09-AFC-3

>>> Keith Freitas <[kfrei@airport.cccounty.us](mailto:kfrei@airport.cccounty.us)> 9/28/2009 9:45 AM >>>

As we discussed, Contra Costa County Airports Division has some concerns regarding the proposed Mariposa Energy Power Plant being proposed near the Byron Airport. In our research there are several unanswered questions regarding possible hazards to aviation from exhaust plumes. Thank you for the opportunity to provide input into to the CEC as you lead the traffic and transportation analysis.

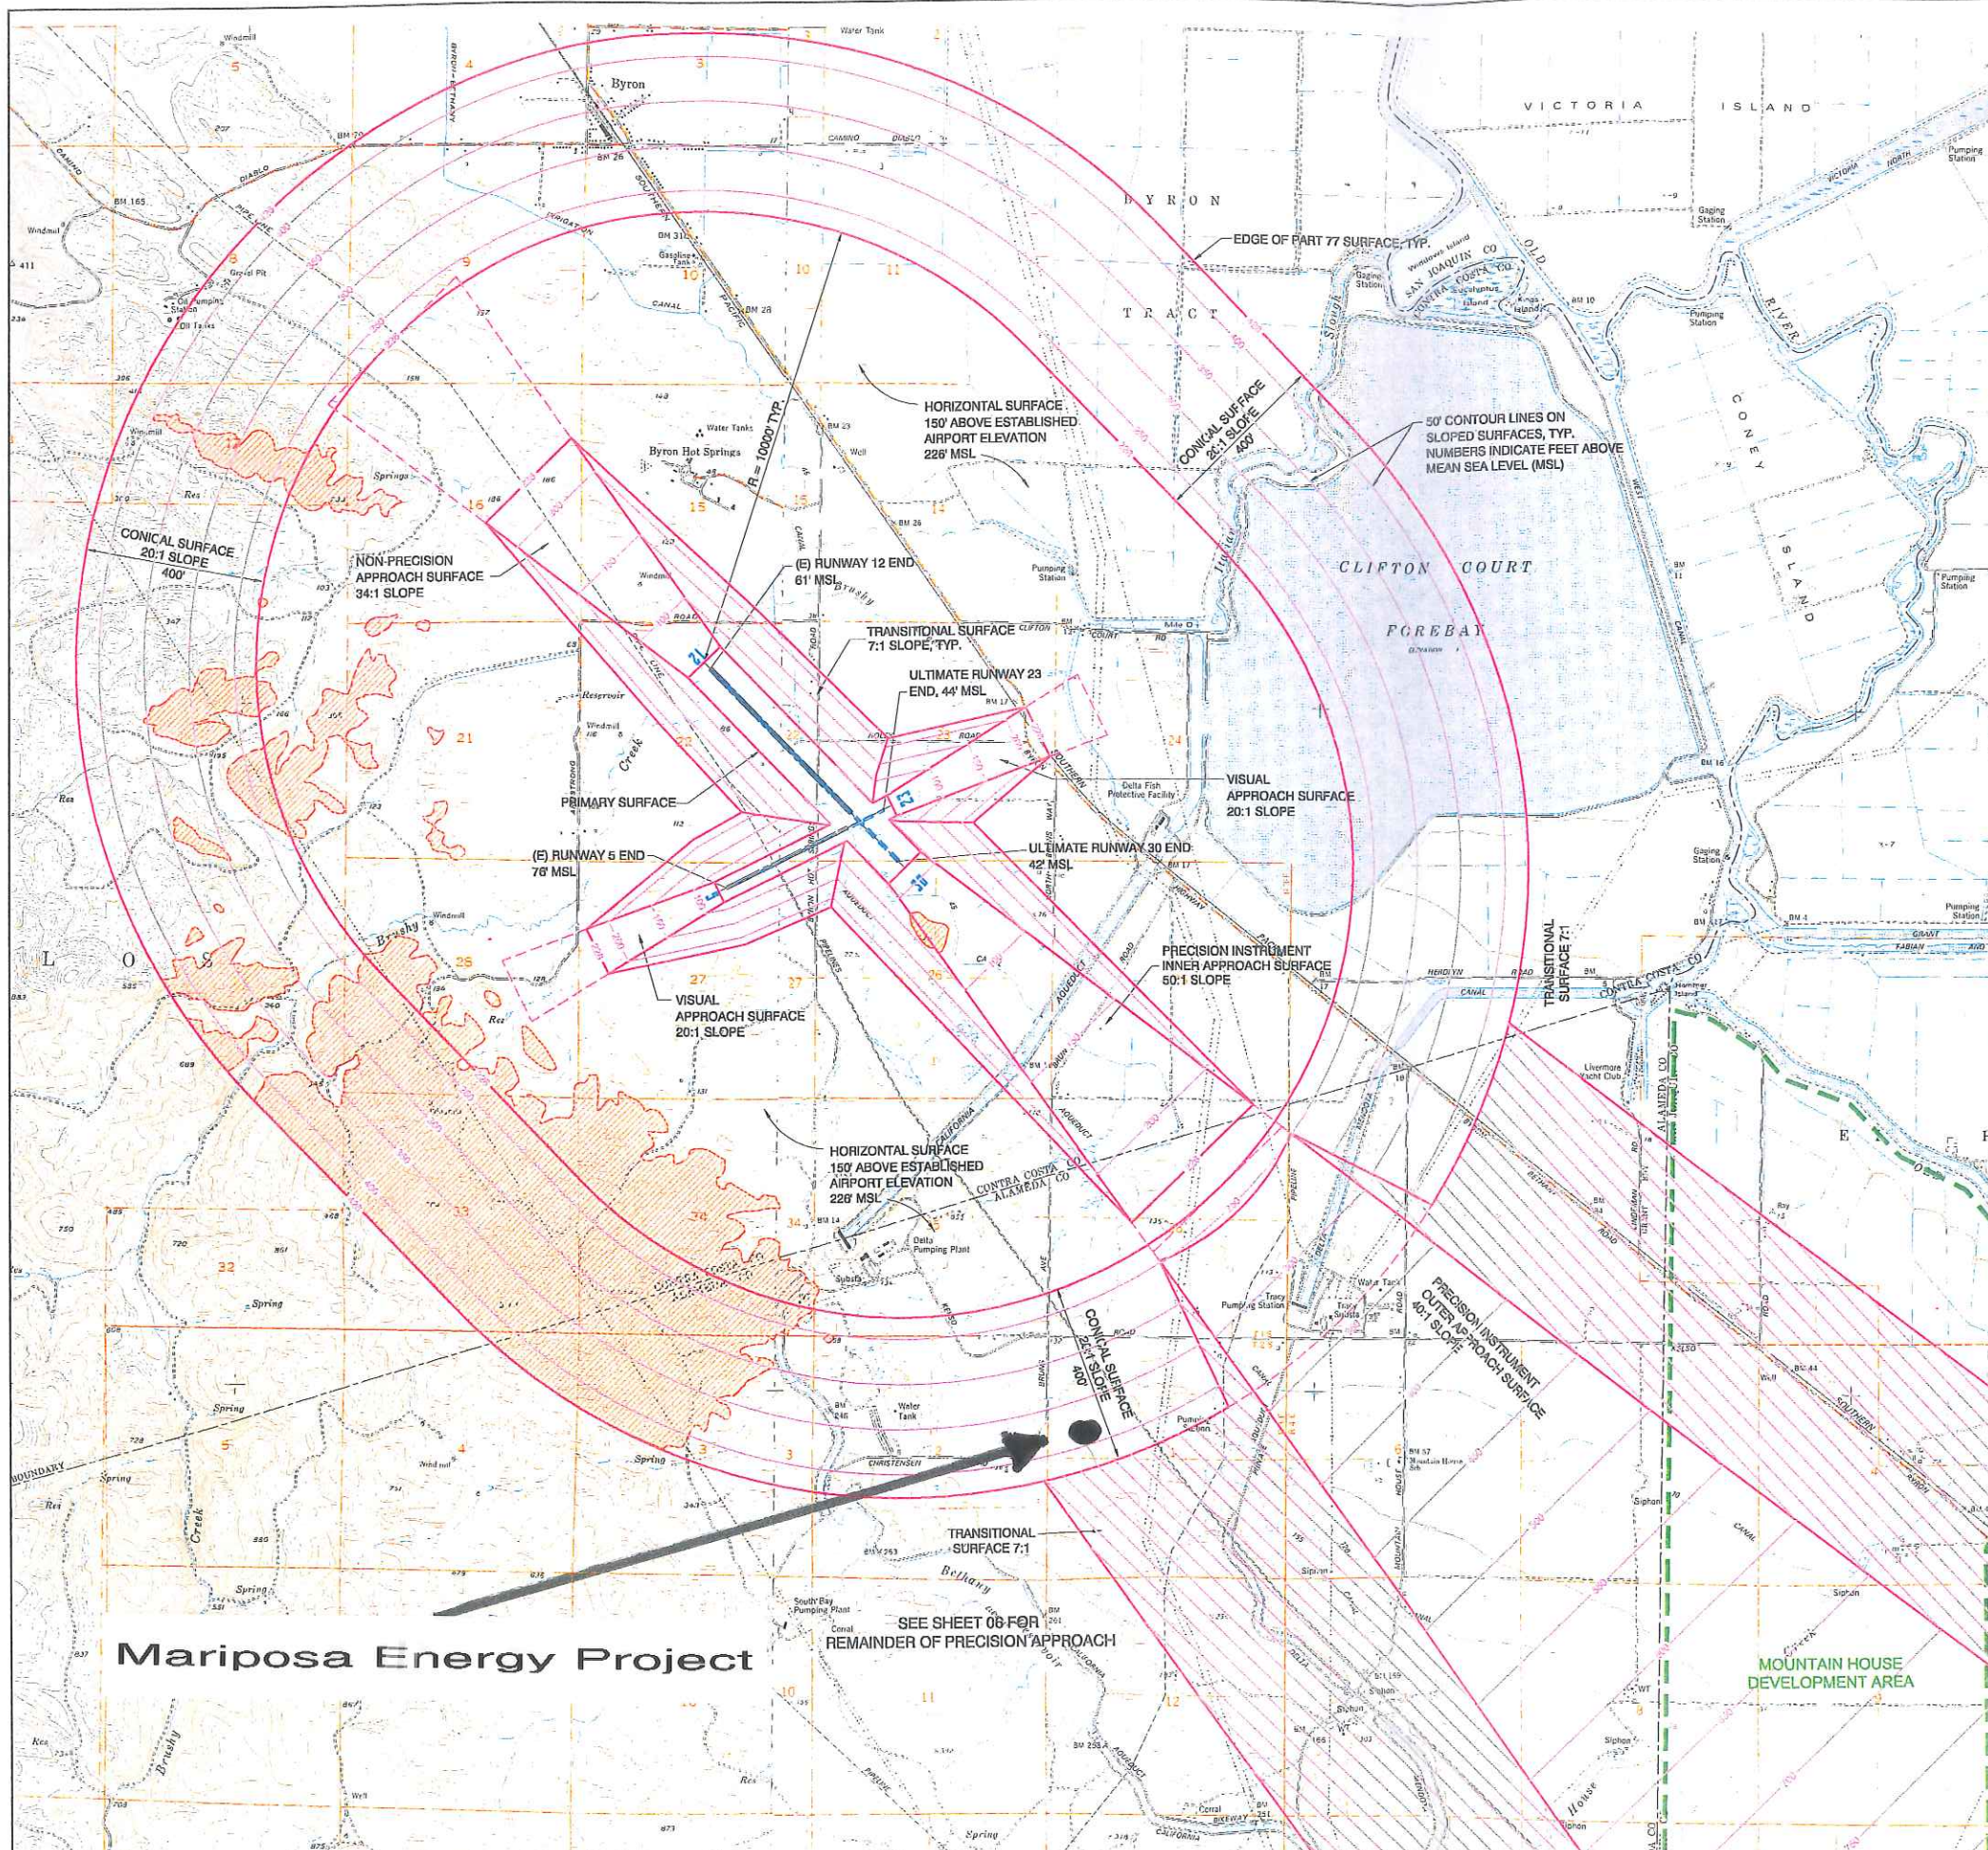
- 1) The proposed power plant is approximately 2.65 miles south east of the Byron Airport, just a few hundred feet from the main precision instrument runway corridor (Runway 30). (Would the proposed location be hazardous to aircraft on an instrument landing, including if they slightly deviated from the prescribed corridor?)

- 2) The power plant site is also near the downwind leg of both Runway's 5 and 23. It appears the site would also be adjacent to the standard "45" entry into the Runway's 5 and 23 traffic pattern. (Would flying at 1000' near or over the proposed location pose a hazard to aircraft in flight?)

- 3) Lastly, the power plant site would be under the "right 45" for aircraft departing Runway 12. This is specifically significant because it is the preferred departure runway for the skydiving company jump planes based on the airfield. (Would flying near or over the proposed location pose a hazard to aircraft in flight?)
